Conceptual Review Agenda

Red Cedar Cir Office and Vehicle Minor Repair

November 23, 2015

Re: Red Cedar Cir - Office and Vehicle Minor Repair

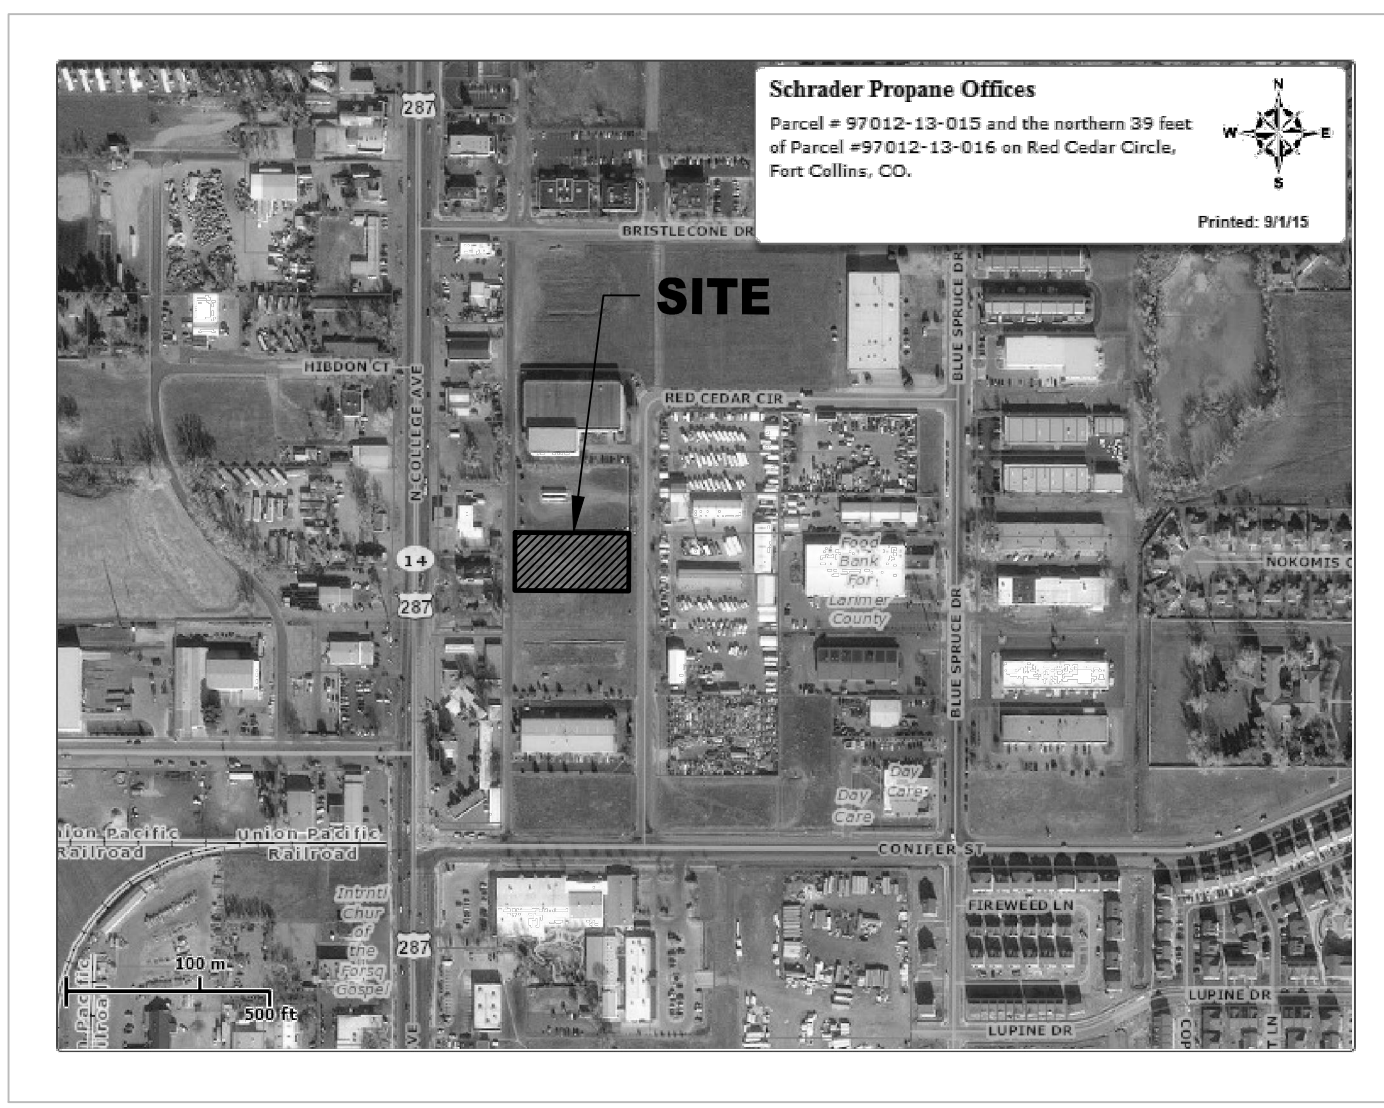
13. I have no concerns regarding where this plan shows the gate and fencing for enclosing the back area as shown, but would have concerns and comments if the gate were to be moved east of the parking stalls.

2. Will the 14 parking spaces shown in the rear of the lot be usable by the public? If not, these spaces will not count towards your parking requirement. Your site plan as shown meets the minimum but staff would prefer if you excluded the 14 spaces in the rear of the lot from your parking calculation.

3. The parking summary shows there are 8 bike parking spaces included on the site plan but the site plan only shows a rack for 4 spaces. Please update the site plan to show where the 4 additional bike spaces will be provided.

4. Chainlink fences are not allowed for screening per Land Use Code section 3.8.11(B). The fencing along the west property line will need to provide screening from adjacent uses.

5. Please consider adding a direct sidewalk connection from the main entrance to the sidewalk along Red Cedar Cir. This will clearly delineate the main entrance and provide a more direct connection for pedestrians.

6. Staff would prefer the fence along the western property line to be moved to the edge of the parking area. This would provide an improved landscape buffer along the alley as the landscaping would be visible from the street.
